A 31/3/22 Section 4.55 Application

Rev Date A06 13 Morgan Road Belrose 2085 31/3/2022 Drawn by Checked by Revision AUST01 JDP JLP

Drawing Notes Revision Control	Client	Drawing	
	Jenny and David Austin	Elevation Shee	et 2
	Project	Scale	D
	Taronnah	1:100 @ A1	
	Project Address	Rev Date	
	13 Morgan Road Belrose 2085	31/3/2022	
	Project Code	Drawn by Checked by	R
B 31/3/2022 S4.55 Application A 11/2/22 CC Application	AUST01	JDP JLP	E

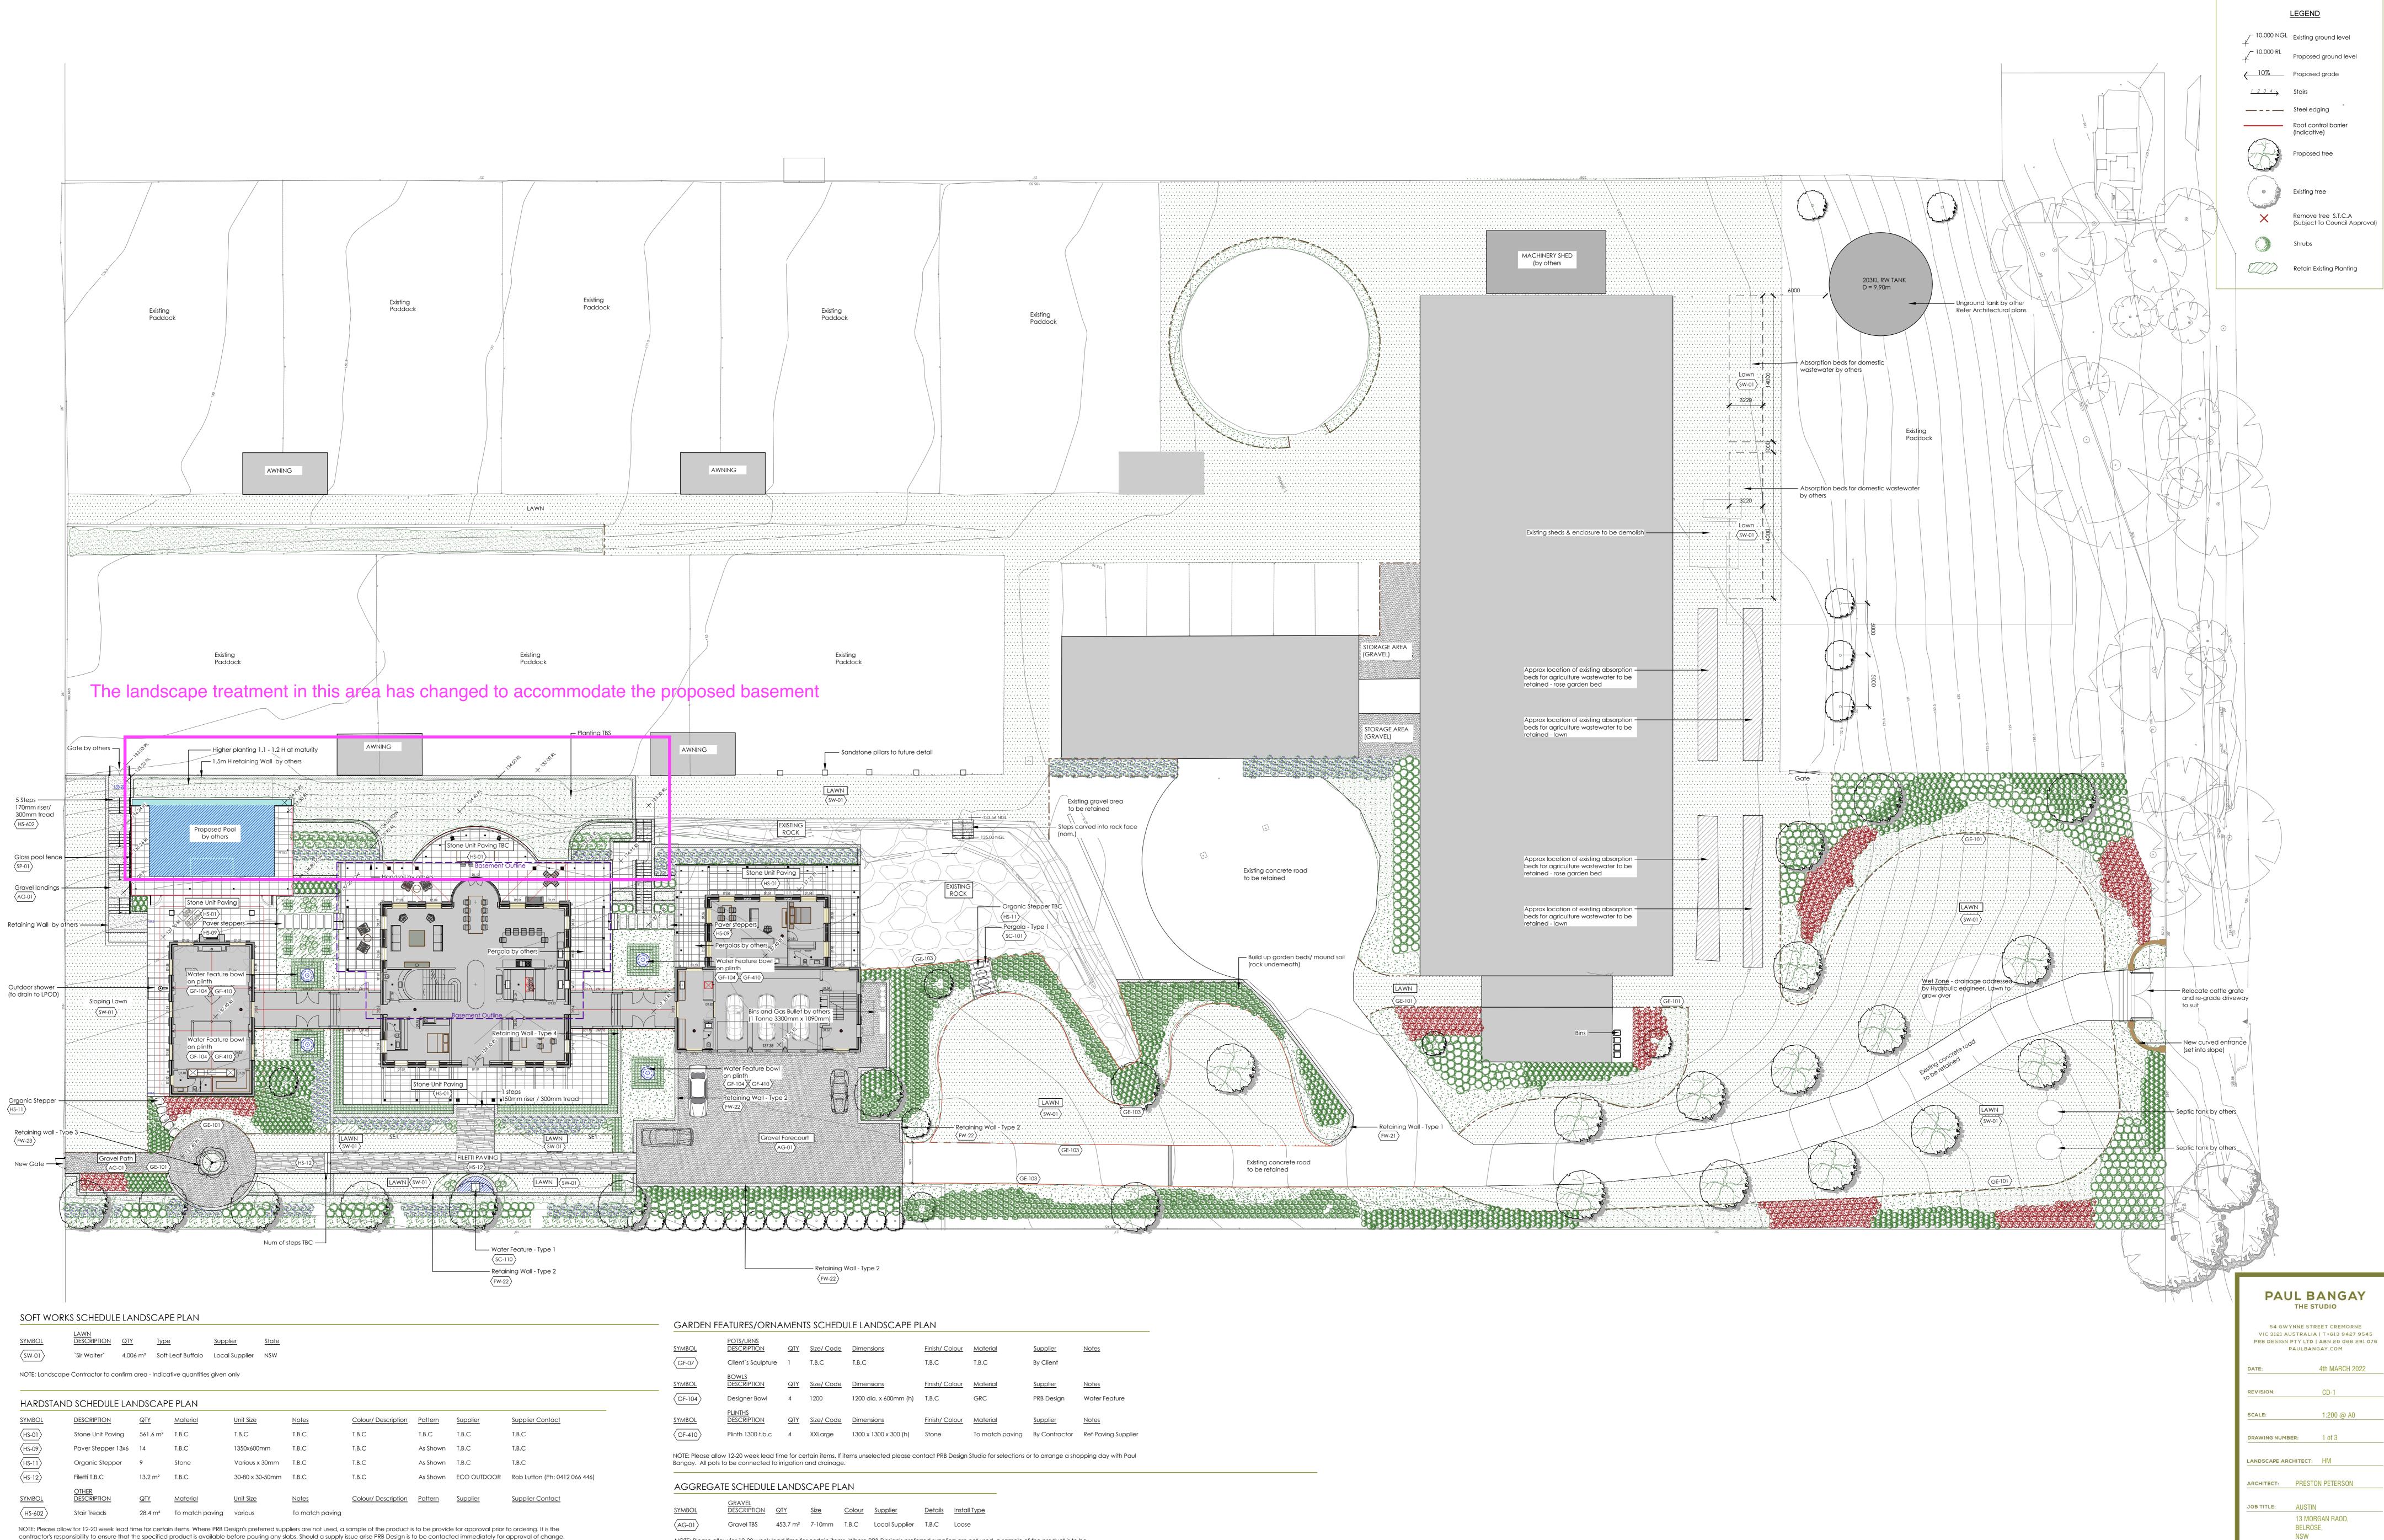
- 6. This S4.55 application seeks approval for the inclusion of a Basement Level under the central pavilion. This will required additional excavation to that proposed in the DA in the area noted as 'A'. However, the demolition of the existing house undertaken in late 2021 under a CDC (issued by Council) uncovered a significant excavation on the site which was backfilled (in the approximate area labelled 'B'. Hence, the actual quantum of excavation to be undertaken to allow for the proposed basement is not overly significant.
